An Bord Pleanála Oral Hearing

Greater Dublin Drainage Application

Submission by
Conroy Crowe Kelly Architects & Urban Designers
and
Waterman Moylan Consulting Engineers

Tuesday, 26th March 2019

Fig. 1.2 - Adjacent Land Zonings and Strategic Road Network

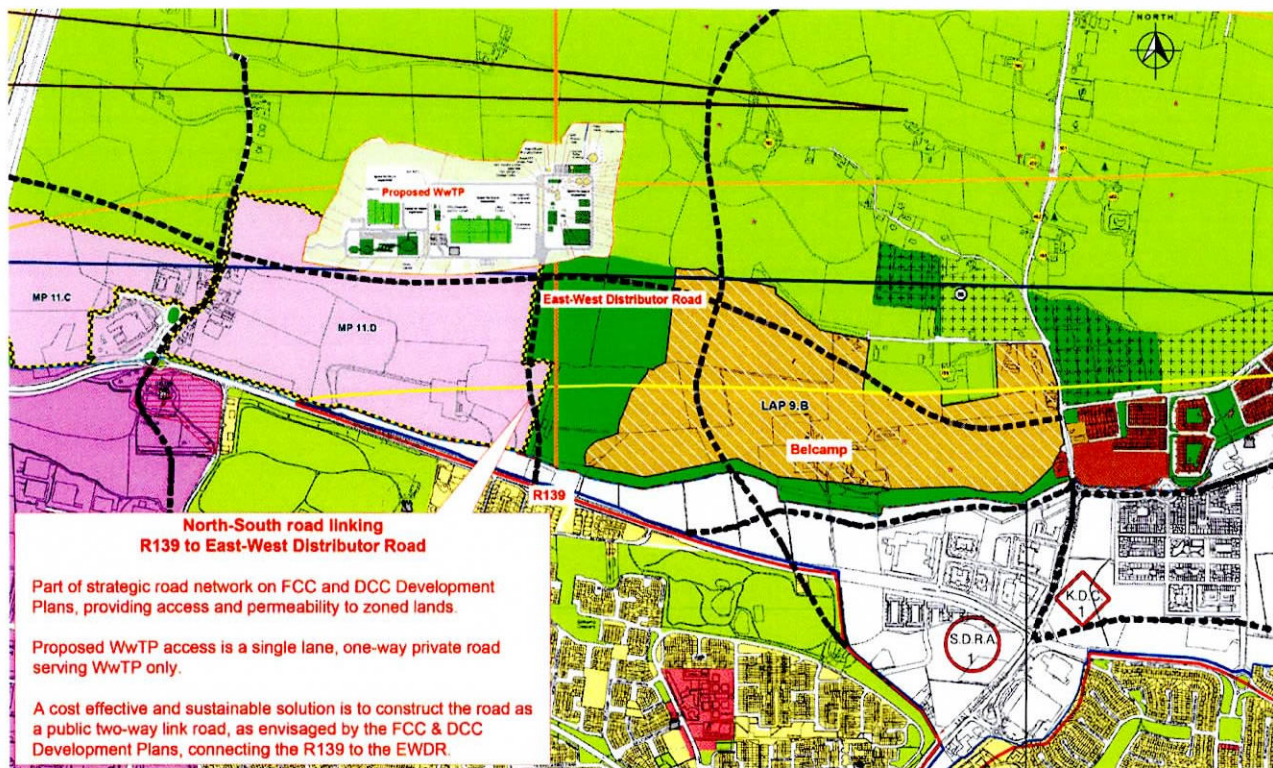
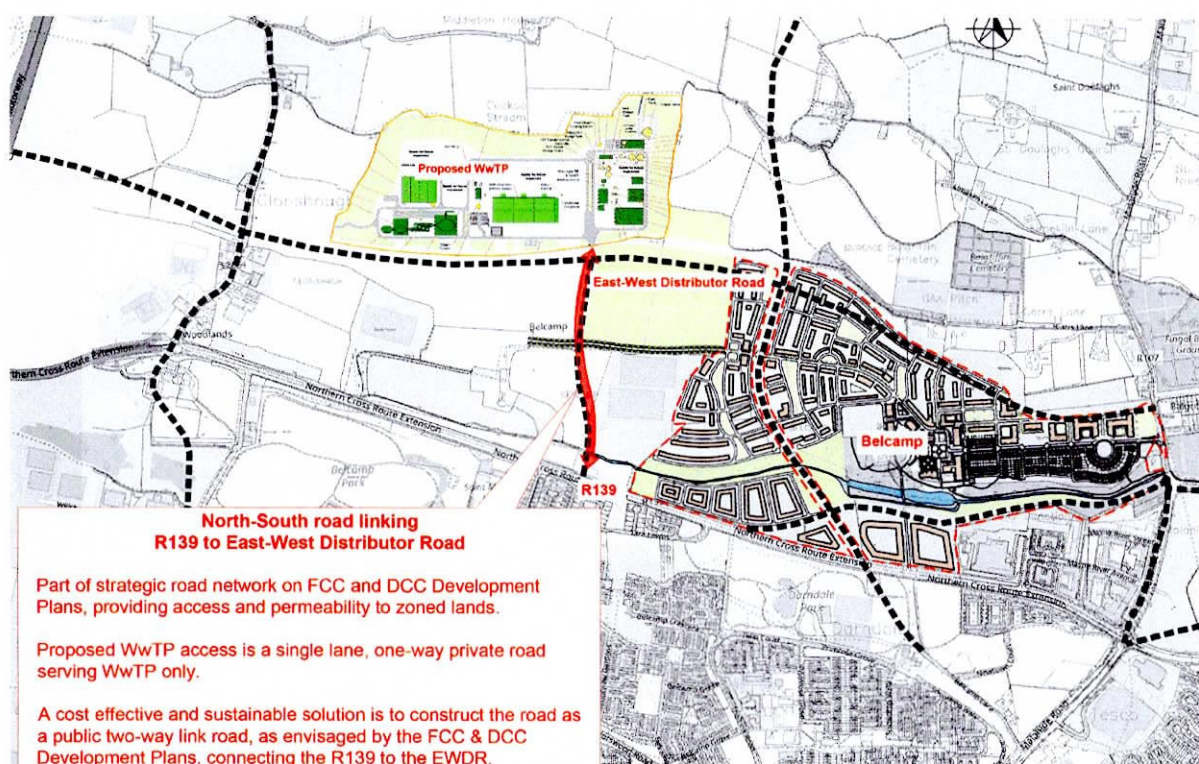
- 1.11 The lands to the south and south-west of the proposed WwTP are zoned *HT – High Technology*, while lands to the south-east are zoned *OS-Open Space and RA – Residential Area*. The Belcamp lands abut the WwTP at the south-east corner, with the RA lands located approximately 200m from the WwTP. The zoned Belcamp lands have a development capacity for over 3000 dwellings and associated mixed-uses. The masterplan layout for these lands is indicated below in the context of the development plan strategic road objective for the wider area. Planning permission has been granted for the first phase of 175 dwellings at Belcamp, accessed from the existing road network, while the delivery of future phases of the development will rely on the implementation of the future strategic road network, including the north-south link to the R139. The Belcamp masterplan includes the provision of an internal spine road running through the Belcamp development and west across the OS zoned lands to connect with the future north-south link road to the R139.

- 1.12 The proposed WwTP access road, by its design as a private single lane route, will preclude public access to the zoned lands from the R139 and will impair the permeability of those lands as proposed in the early road designs prepared by Atkins for FCC. The access road as proposed will create a barrier between HT zoned lands to the west and OS and RA zoned lands to the east, forcing otherwise short journeys from one side of the road to the other to be re-routed along the busier arteries of the R139 and EWDR, and precluding direct pedestrian and cycle routes between the two sides.

- 1.13 The applicant fails to satisfactorily take account of the zoning of adjoining lands and the interconnectivity between them. The north-south link road is key in opening up the adjacent HT and RA lands for development. The Atkins scheme makes provision for spur roads to the HT lands in the west, and the RA lands in the east. It is a critical piece of road infrastructure in the orderly development of the Dublin North Fringe and Fingal South Fringe area.

Figure 2.2: Proposed Access from R139 (by Irish Water)

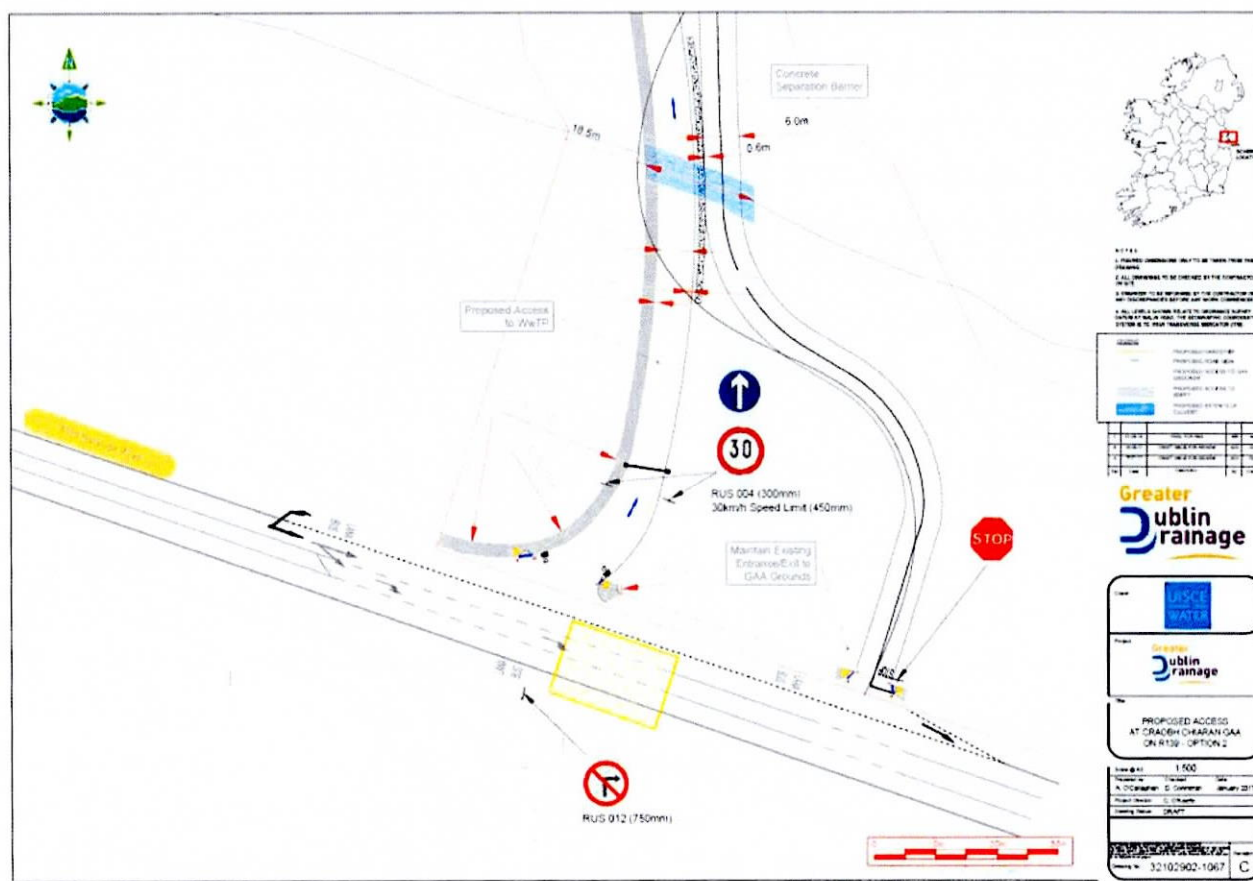
2.6 Included below is figure 2.2, from the Transport and Traffic Brief prepared by Tom Cannon of Irish Water delivered to An Bord Pleanála on 21 March last. Irish Water propose to provide another access point to the R139 opposite the access to Cora Park, at the same point of access as the proposed County Development Plan distributor road.

2.7 The proximity of these junctions will significantly reduce the safety of all road users unless the junction at Cora Park is signalised and pedestrians and cyclists provided for. Conflicting right-hand turn movements from GAA lands and Cora Park pose a significant hazard to road users.

3.5 The proposed junction at the R139 should amalgamate the WWTP access and GAA lands access in one link road, located opposite Cora Park and be fully signalised with pedestrian and cyclist facilities.

Figure 2.4: WWTP Egress Point to Stockhole Lane

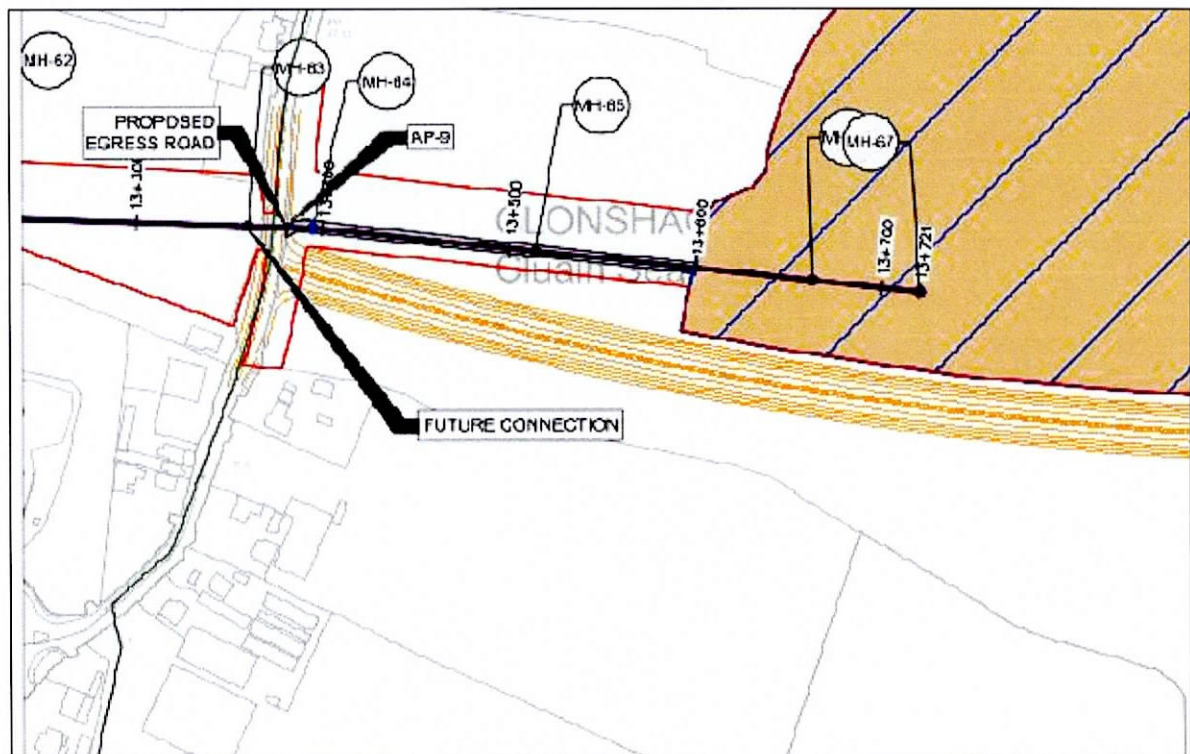
- 2.13 It should also be considered how the EWDR link to Stockhole Lane can be delivered without disrupting service traffic from the WWTP to Stockhole Lane. Figure 2.4 below shows the link to Stockhole Lane proposed as one-way conflicting with the proposed EWDR as it meets Stockhole Lane.

- 2.14 The EWDR junction with Stockhole Lane conflicts with the egress road from the WWTP. When the EWDR junction is being constructed, should a two-way access with the R139 be in place as we have suggested, this would allow the future EWDR junction with Stockhole Lane to be constructed without disruption to service vehicles exiting the WWTP. Service vehicles could exit the site via the R139 while the EWDR junction is delivered at Stockhole Lane. Egress from the WWTP could later be delivered directly onto the EWDR and the egress road, as proposed by Irish Water, could be decommissioned and made available for development. The alignment of

Figure 2.6: Existing North Fringe Sewer downstream of Gannon Lands

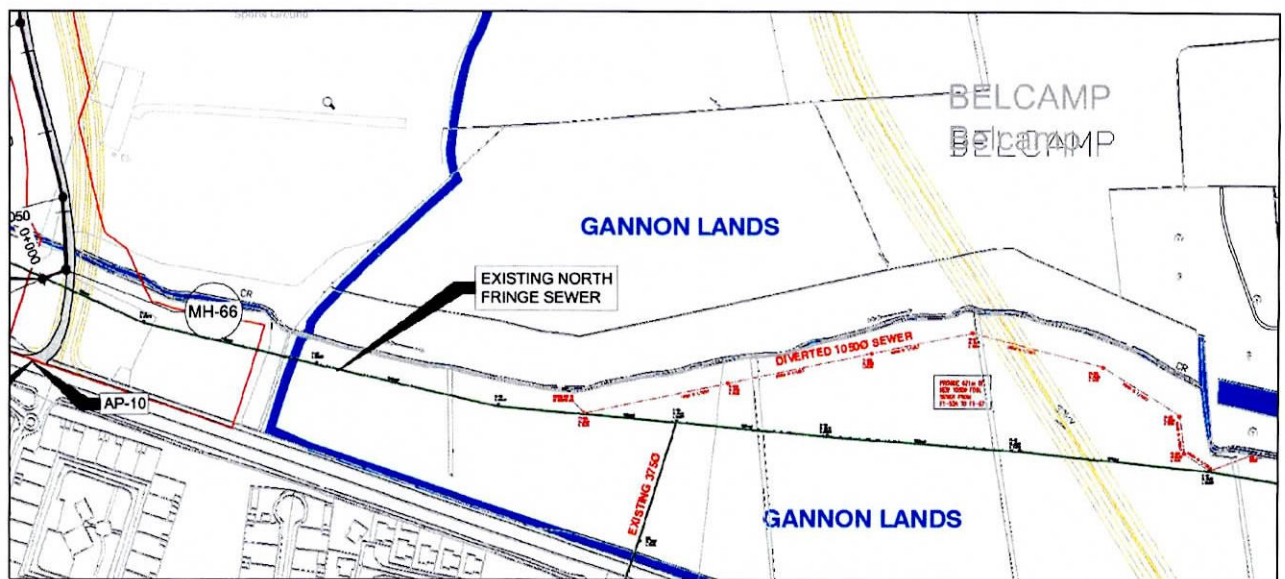
- 2.22 The alignment of the existing 1050mm sewer is indicated in green in figure 2.6 below. It passes straight through Gannon lands downstream of the sewer diversion point and does not follow the Mayne River as it does further upstream, which would have made available more land to develop. There is also a 375mm sewer laid from Cora Park across the R139 to the 1050mm sewer in Gannon land.

- 2.23 If the 1050mm sewer is to become redundant, the abandonment of this sewer would provide for greater flexibility in design and housing layout for those residential zoned lands in Gannon control. The existing 375m sewer could be diverted into the future development sewer network and upsized to accommodate existing flows before discharging back into the 1050mm sewer to the very right of the image above.

- 3.7 The alignment of the sewer diversion be designed with the future R139 link road north to the WWTP borne in mind.
- 3.8 The existing 1050mm sewer downstream of the diversion point be made redundant or realigned to prevent unnecessary sterilisation of development lands. Similarly, at the Stockhole Lane junction, greater consideration of sewer alignment to prevent developable land sterilisation.
- 3.9 The sharp bend in the diverted sewer north into WWTP may give rise to head losses and increase risk of surcharging of the sewer. Irish Water should be required to address the event of surcharging and resultant pollution of the river Mayne in their submission.
